**PLANNING DIRECTOR'S SPECIAL PERMIT  
FOR SINGLE FAMILY RESIDENTIAL IN A PUD**

**FILE:** P99-071

**PROJECT NAME:** Renaissance Homes in Northpointe Park - Village 12

PLAN 652 - MONTEREY FRONT ELEVATION A

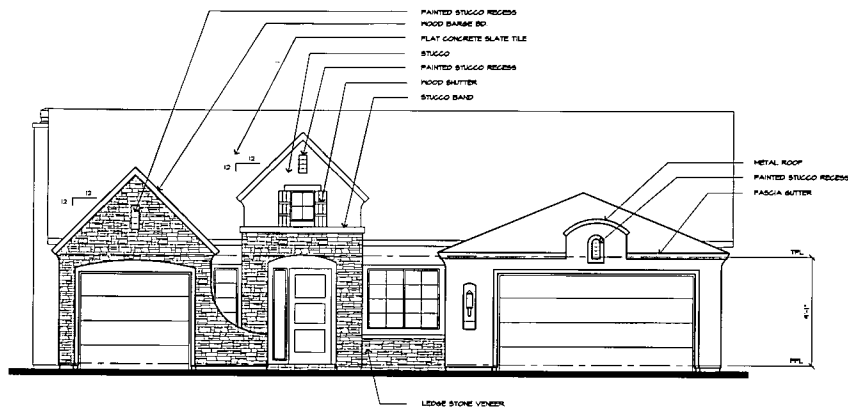
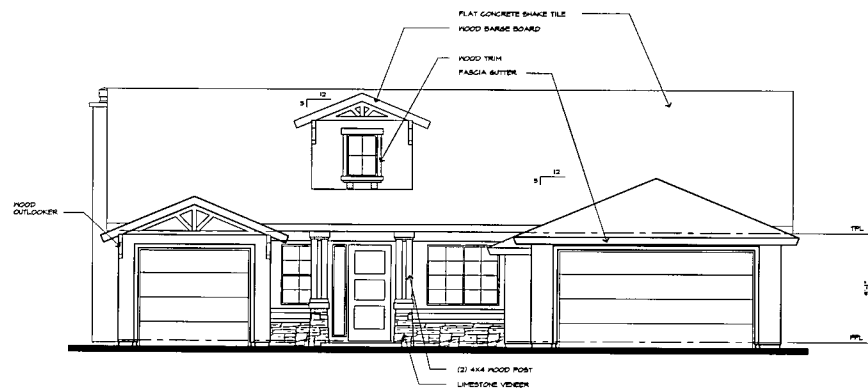
Plan 652: Planning staff is concerned about Plan 652 because: 1) no living area faces the street unless the third car garage is converted into living area and 2) the majority of the front elevation is devoted to the garages. Planning staff would suggest the following conditions be required for Plan 652: 1) A maximum of 50 percent of all the Plan 652 homes throughout Village 12 may be constructed with the three car garage option; and 2) Plan 652 shall be allowed on interior lots only unless the third car garage is converted to living area. The applicant has agreed to these conditions. If compliance with the 50 percent maximum 3 car garage condition on Plan 652 proves infeasible as the homes are built, the home builder can request a modification to the condition through a Planning Director's Special Permit Modification. Planning staff will work with the applicant on such a request and the Planning Director may approve, modify, or deny the requested condition change.

- b. A maximum of 50 percent of all the Plan 652 homes throughout Village 12 may be constructed with the three car garage option;
  - c. Plan 652 and Plan 653 shall be located on an interior lot only unless constructed with living space in the third car garage;

PLAN 653 - MONTEREY FRONT ELEVATION

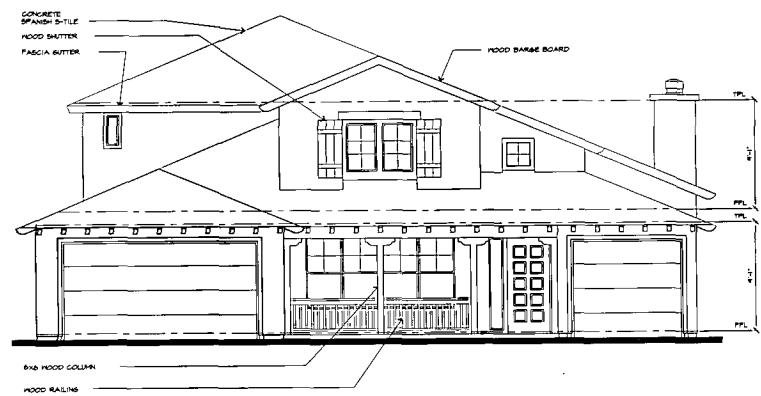
1. We recommend that any roof projections (i.e.: vents, pipes) be located in the back of the home, not visible from the street.
2. On the Plan 653 with the Monterey style elevation, we would like to suggest that you consider changing the style of window for the upper bath to the same style as the Plan 653, elevation B.
3. Please clarify the gable treatment on Plan 654, elevation B.
4. Please clarify if a door to the outside is missing from the single car garage on Plan 655.

FIGURE V-2 FENCE WITH STEEL POST

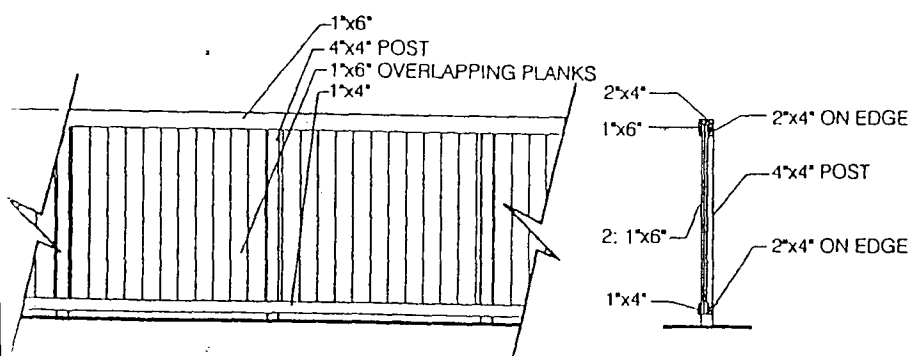
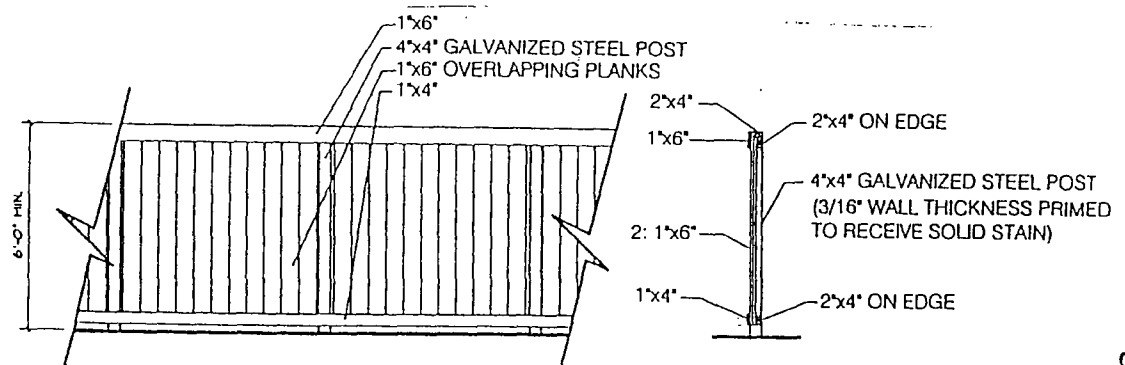
Furthermore, when a fence is adjacent to a park site, open space or school, galvanized steel posts shall be used in lieu of wood. This Variation is shown in Figure V-2. Refer to exhibits VI-4 and VI-5 for the location of fences with steel posts.

9. Fencing and Walls - No masonry walls are required within Village 12. A wood fence with steel posts shall be required along the west side of Lot 20 adjacent to the community park per Exhibit 10. All other fencing shall be wood fence with wood posts per Exhibit 10. Side and rear yard fences visible from the park and other public areas which are composed of wood shall have continuous top and bottom rails. All fencing visible to the public shall have a semi-transparent stain in a neutral tone to be specified by the Natomas Park Design Review Committee. The location of fencing for interior and corner lots shall be as shown on Exhibits 3 and 4, specifically for corner lots fencing shall not commence until the back of the
